EXPLANATORY NOTE – LANDSCAPE & DESIGN

DATE:	25 April 2024	CONFIDENTIALITY:	Public
SUBJECT:	Appeal Ref: APP/R3705/W/24/3336295 - Explanatory Note – Landscape & Design		
REFERENCE:	Note.JW.PINS.001	AUTHOR:	JW
CHECKED:	DH	APPROVED:	DH

Project
LAND NORTH EAST OF J10 M42, DORDON

Drawing Title
OFFSITE LANDSCAPING - PUBLIC ACCESSIBILITY PLAN

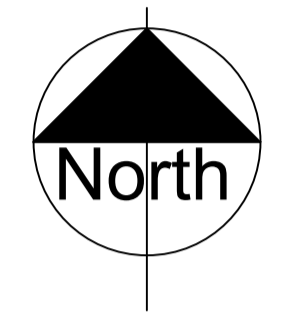
(ii) Clarity on the extent of the areas of the “blue land” to be given over to off-site landscaping, and their status

(iii) Clarity on the proposals for the rest of the “blue land”

- 1.28. The Appellant has been clear on the extent of proposed blue land for potential off-site landscaping since the outset of the planning application. For the avoidance of doubt, the plan appended to this Note (plan ref: 00092 Rev PL2) also identifies the areas for potential off-site landscape and visual mitigation as shaded pink.

- a) Submit a plan(s) showing a detailed planting scheme for the off-site landscape mitigation proposals (i.e. within the pink shaded areas of plan ref: 00092 Rev PL2), for approval by NWBC;

- 1.30. The remainder of the blue land (i.e. the blue line area not shaded pink / hatched green on plan ref: 00092 Rev PL2) would remain in its existing agricultural use, albeit noting that a public footpath also crosses the land. This being the AE46, which is proposed to be diverted and upgraded (subject to agreement by the highways authority) in accordance with Design Parameters in the submitted Design Guide.
